# Access Compliance Report

## Public Rights-of-Way

Intersection ID: 49817	Main Street: ASHLEY_VIEW_DR	Cross Street: SIDNEY_CREST_AV	Location: E
ADA ID: F9B34FB572F1	Ramp Type: PerpDiag	Initial Pass/Fail: Fail	Overall Compliance: No
Severity Score: 33.75			
Codes/Mitigation Info/Possible Solution		Field Measurements/Component Compliance

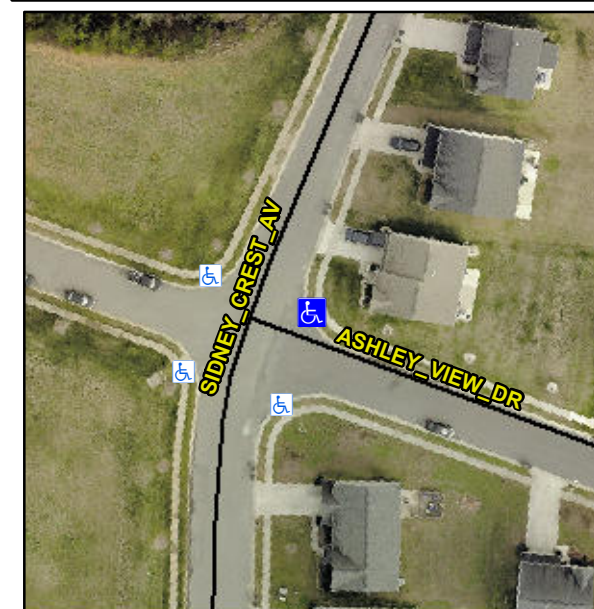
**Not Found, R304.5.1, R304.2.2, R304.5.3**

Compliance	Description	Data	Compliance	Description	Data
N/A	Ramp Length (in)	48.0	No	Ramp Slope (%)	11.4
No	Ramp Width (in)	40.0	No	Ramp XSlope (%)	6.7
N/A	Flare Type LT	N/A	N/A	Flare Type RT	N/A
N/A	Flare Slope LT (%)	N/A	N/A	Flare Slope RT (%)	N/A
N/A	Flare Traversable LT?	N/A	N/A	Flare Traversable RT?	N/A
N/A	Landing Length (in)	N/A	N/A	DWS Provided?	N/A
N/A	Landing Width (in)	N/A	N/A	DWS Contrast?	N/A
N/A	Landing Slope (%)	N/A	N/A	DWS Length (in)	N/A
N/A	Landing X Slope (%)	N/A	N/A	DWS Full Width?	N/A
N/A	Landing Curb? (Y/N)	N/A	N/A	DWS Offset (in)	N/A
N/A	Shared Landing?	N/A			
N/A	Gutter Ponding?	N/A	N/A	Gutter Slope (%)	N/A
N/A	Gutter Lip Ht (in)	N/A	N/A	Gutter X Slope (%)	N/A
N/A	Painted X Walk1?	No	N/A	Painted X Walk2?	No
	X Walk 1 Direction	To NW		X Walk 2 Direction	To SW
N/A	X Walk 1 Width (in)	N/A	N/A	X Walk 2 Width (in)	N/A
	X Walk 1 Slope (%)	5.4		X Walk 2 Slope (%)	1.1
	X Walk 1 X Slope (%)	4.4		X Walk 2 X Slope (%)	6.2

**Remove & Replace Curb Ramp With Two New Directional Ramps or Equivalent.**
